Re: PSD-06-02 (Issued May 22, 2007)
Tacoma, Washington Kraft Mill
Supplement to 2010 PSD Amendment Application

Appendix B – Fuel Moisture Questions and Responses

Appendix C – Fuel Moisture Correlated with NOX Emission Rates

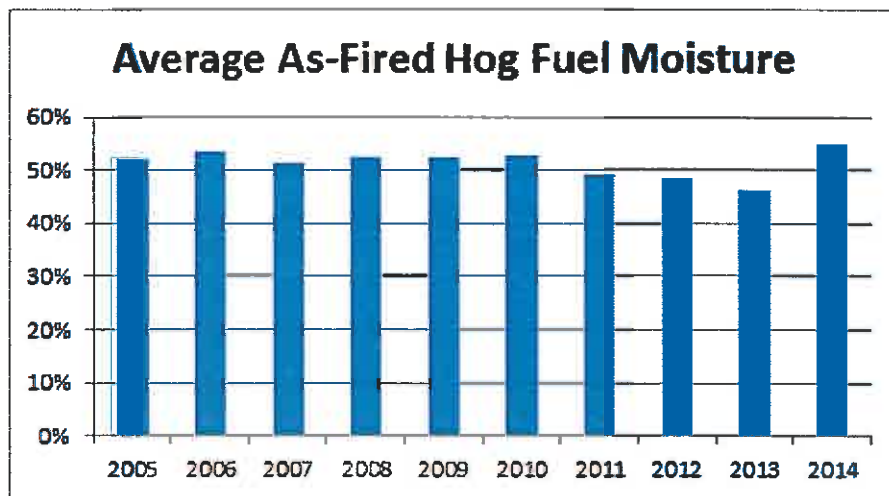
In the STK-NOx-HCL Briefing document provided back on April 10, STK had a graph of NOx 30-Operating-Day rolling averages for July 2012 to present. Does STK have similar NOx data going back to the pre-generator project timeframe? EPA is wondering if there was actual NOx emissions data that could be used to pinpoint when the boiler's emissions changed from the pre-modification rate of around 0.18 lb/MMBtu to the current levels.

As additional background, STK also has data on belt-feed fuel moisture, which better reflects the moisture of the fuel which is actually burned. The (belt feed) fuel moisture is consistent from 2005 through 2010, drops a few percentage points during 2011 through 2013 before rising again so far this year. The yearly averages are:

Year	Average As-Fired Hog Fuel Moisture
2005	52%
2006	54%
2007	51%
2008	52%
2009	52%
2010	53%
2011	49%
2012	48%
2013	46%
2014	55%

As mentioned previously, STK has pursued drier fuel at times when CO emissions and boiler efficiency become issues during the wet season. Other than these discrete times STK has not purposefully pursued a particular fuel moisture content.
